The subject property comprises 1.53 acres at the northwest corner of the intersection of Danken Lane and Executive Drive, with approximately 265 feet of frontage on Executive Drive and 255 feet of frontage on Danken Lane and is zoned “C-3” Commercial District. The property is currently fully paved and utilized as a parking lot for Bluebonnet Motors employees and vehicle inventory.

The applicant proposes to construct a new building on the property to be utilized as a diesel mechanic shop for Bluebonnet Motors (see Attachment 3). The proposed building would be 180 feet wide by 30 feet deep and 20 feet in height with 8 mechanic bays. The building is proposed to be constructed of metal and include a 100% exterior metal façade (see Attachment 4). The applicant’s proposed building would not meet building design requirements adopted to improve the quality and aesthetics of new construction, help provide human scale to the façade of buildings, and provide a more interesting façade appearance.

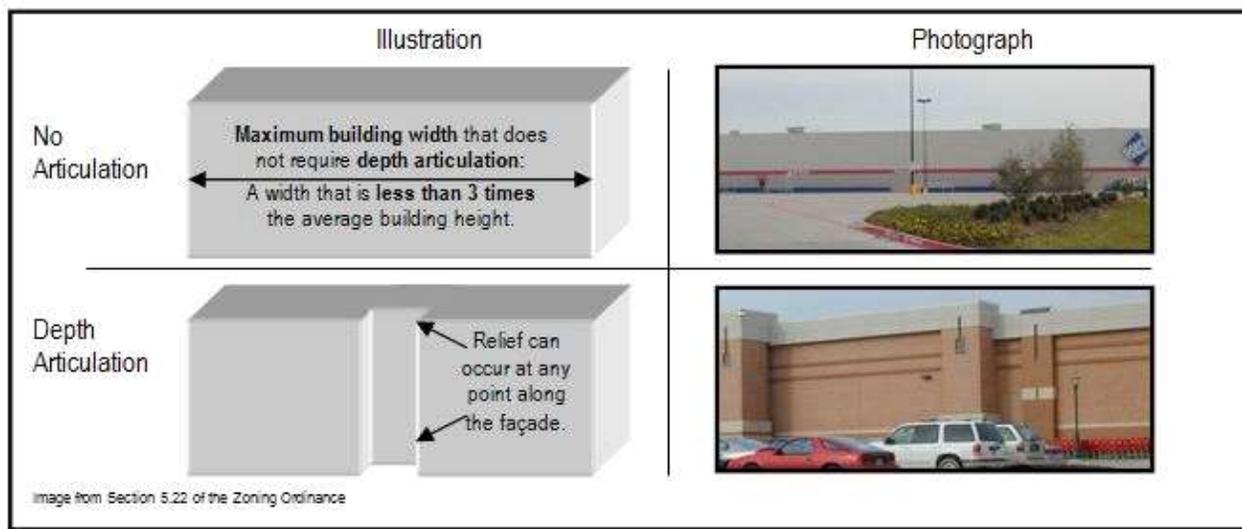
The horizontal articulation requirements for the proposed building only apply to the building facades facing Danken Lane and Executive Drive. The front facade as proposed would not meet the minimum horizontal articulation requirements. The width of the front façade is 180 feet with an average height of 20 feet. According to the design standards, no portion of the façade shall extend for more than three times the average height (60 feet) without depth articulation. To meet the design standards, there would need to be a minimum of 2 horizontal offsets (relief) at least 3 feet deep (15% of the average building height), extending a width of at least 18 feet (10% of the width of the building façade), positioned on the façade so that no portion of the façade would extend for more than 60 feet without an offset. The required offsets could be an inset or a protrusion as depicted in the following illustration:

Vertical Articulation (Attachment 8, Chapter 144 Section 5.22-3(c)(2)):

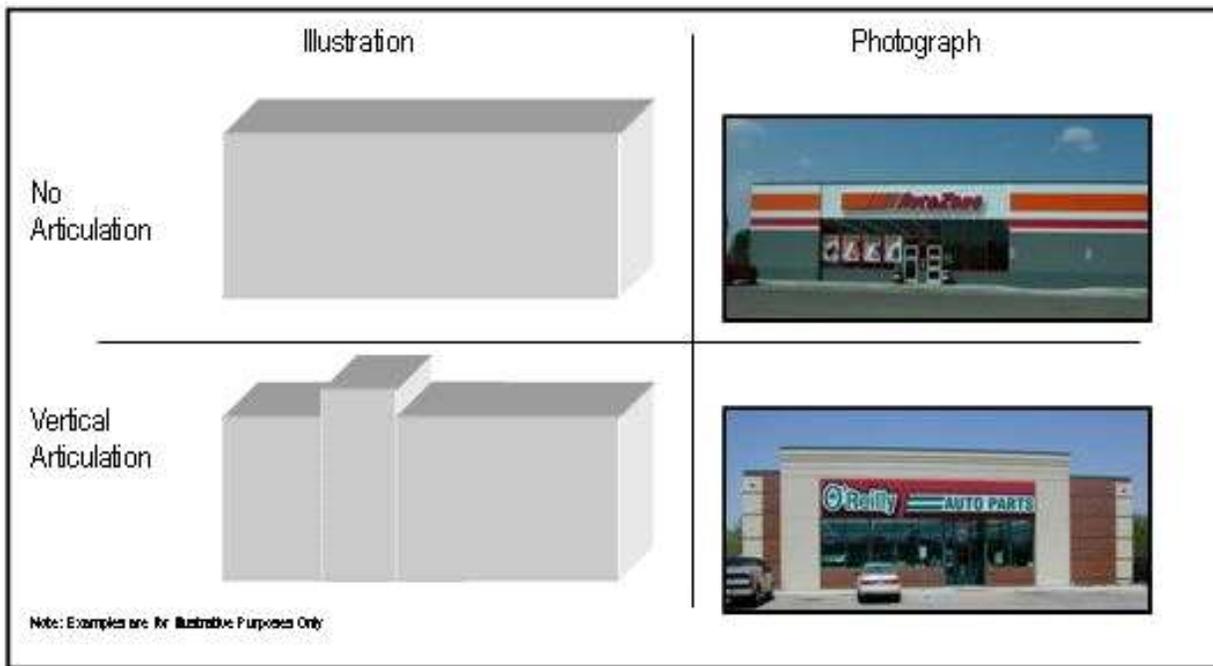
The Vertical articulation requirements for the proposed building also only apply to the building facades facing Danken Lane and Executive Drive. The front facade as proposed would not meet the minimum vertical articulation requirements. The width of the front façade is 180 feet with an average height of 20 feet. According to the design standards, no portion of the façade shall extend for more than three times the average height (60 feet) without a change in façade elevation. To meet the design standards, there would need to be a minimum of 2 vertical offsets (relief) with a change in elevation height of at least 3 feet (15% of the average building height), extending a width of at least 18 feet (10% of the width of the building façade), positioned on the façade so that no portion of the façade would extend for more than 60 feet without an offset. The offsets can be of varying heights as long as the minimal standard is satisfied as depicted in the following illustration:
